NZ NOTICES TO MARINERS **EDITION 15**21 July 2017

NZ 136/17 NEW ZEALAND – North Island – East Coast – Marsden Point. Depths, Dredged Area and Anchorages.

NZ 5214

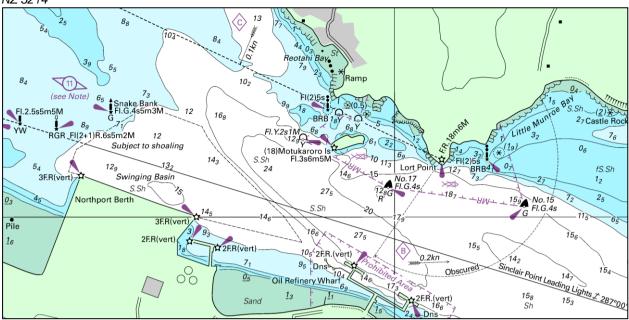
Insert the accompanying block showing amendments to dredged areas

and depths, centered on:

35° 49'.86S., 174° 29'.75E.

NZ5214

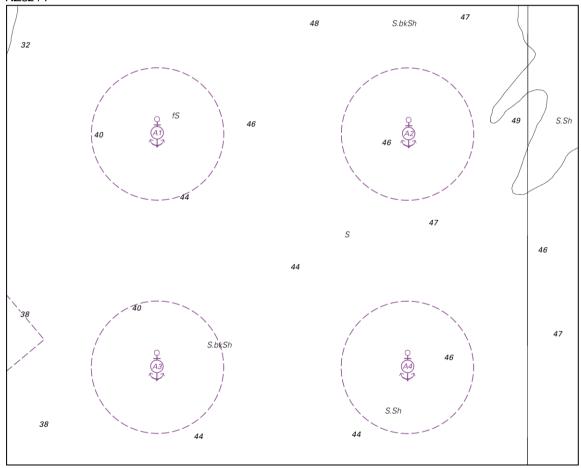
the accompanying block showing amendments to anchorages,

centered on:

35° 52'.88S., 174° 35'.27E.

NZ 5215

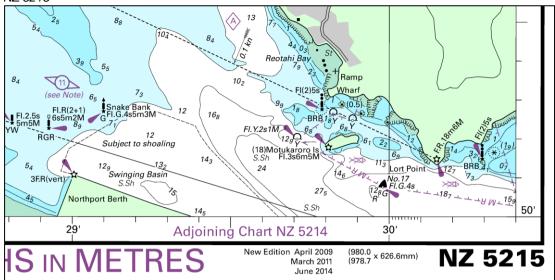
Insert the accompanying block showing amendments to dredged areas

and depths, centered on:

35° 49'.81S., 174° 29'.66E.

NZ 5219

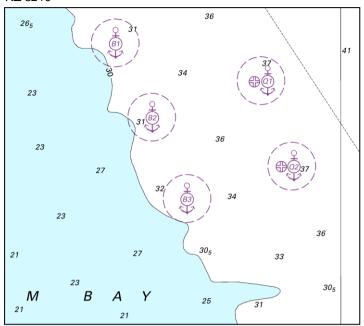
Insert the accompanying block showing amendments to anchorage

areas, centered on:

35° 52'.90S., 174° 35'.22E.
